Kadena Sportswear Limited (Extension)

Standard Factory Building no. 5 & Plot no. 113-121, Comilla EPZ, Comilla

6 & 31 December 2023

Observation-13: Lack of drawing. (Chemical Store Shed, Sub Store Shed, Maintenance Store Shed, Sub-Station Shed-2)

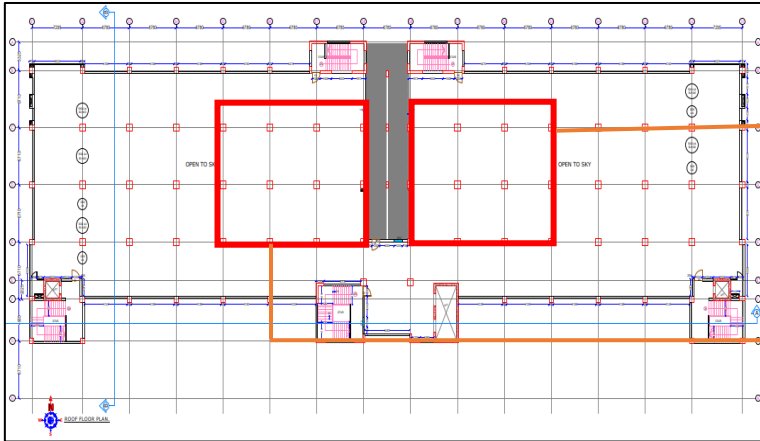
Description: As-built structural and architectural drawings were not found for these sheds. The building engineer is required to survey the structure and prepare a full set of as-built drawings.

Roof Layout

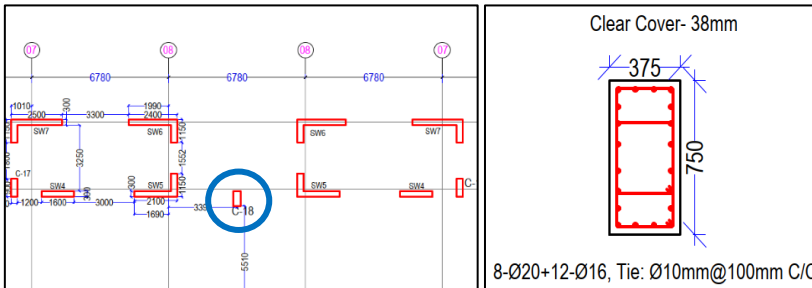
Undocumented Roof Shed

Description: During inspection, two steel sheds were found on roof of MS SFB-2 building. But in as-built drawing no roof structure was mentioned.

Column Layout & Rebar Details

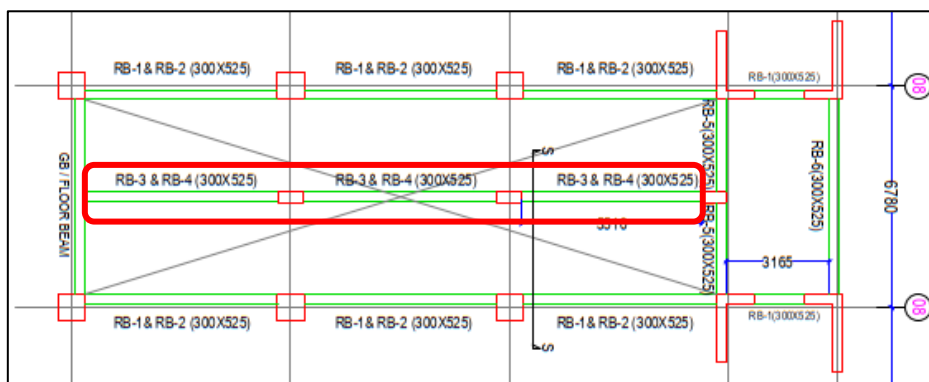
Description: During inspection, 16 nos. rebar of column C-18 at ramp area in 5th floor were found instead of 20 nos. rebar.

Observation-18: Column susceptible to trolley impact. (MS SFB-2)

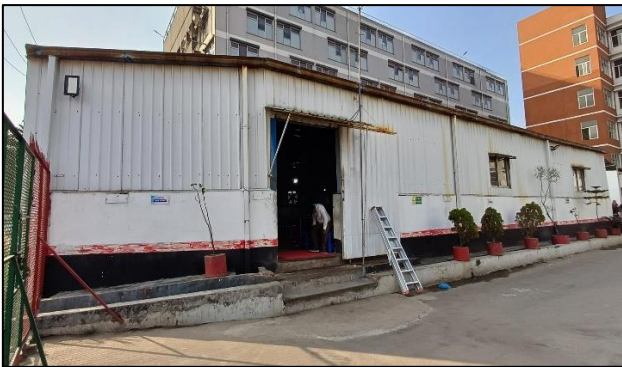
Description of observation: During inspection, some column of MS SFB-2 building had the sign of trolley impact. The building engineer is required to provide barriers around the column to avoid trolley impact.
